PRODUCT CHANGE NOTICE

Shipping Tube Change for Intersil MSOP Packaged Products

**Refer to:
PCN11059**

Date: June 17, 2011

Tube Outlines – PCN11059

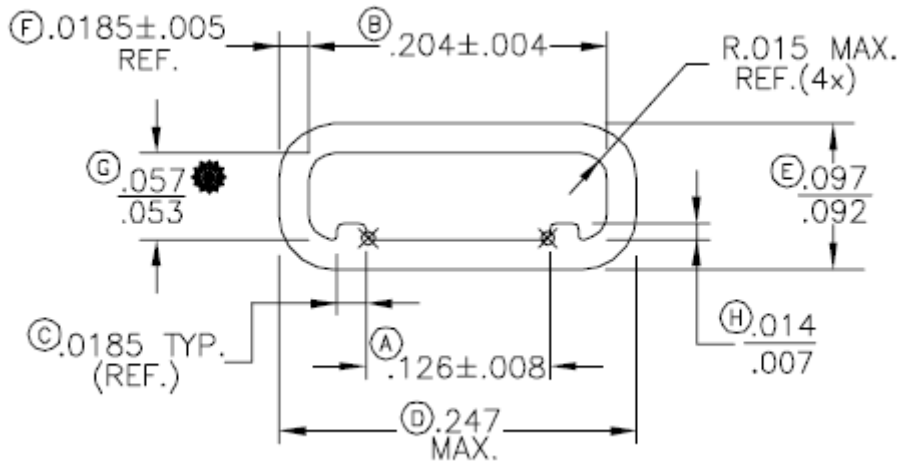
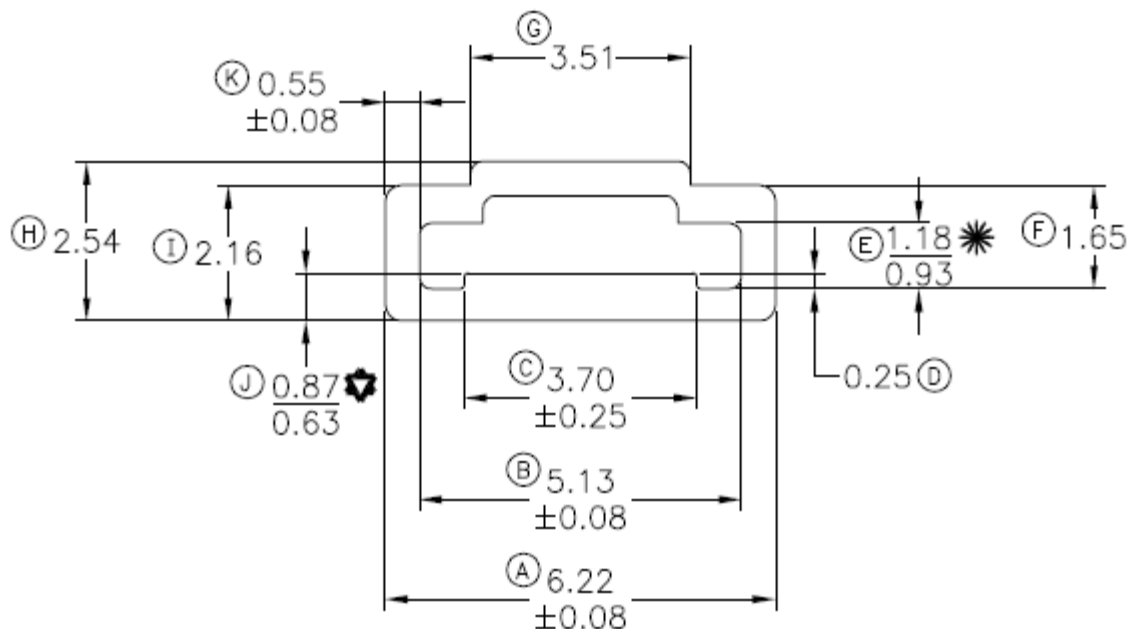
This notice is to inform you that Intersil is changing the anti-static tube used for packing/shipping of MSOP (Mini Small Outline Plastic) packaged products from the Carsem, STATS ChipPAC, and Unisem facilities located in Malaysia. The change from a round profile (current) tube to a rectangular / square profile (new) tube will eliminate lead contact with the tube body thereby reducing the potential for bent leads.

The industry standard tubes are made of an anti-static material. There will be no change in tube length or the quantity of units packed in a tube. Dimensional information and drawings of each type are included on the next page for reference.

New – Rectangular / Square Profile
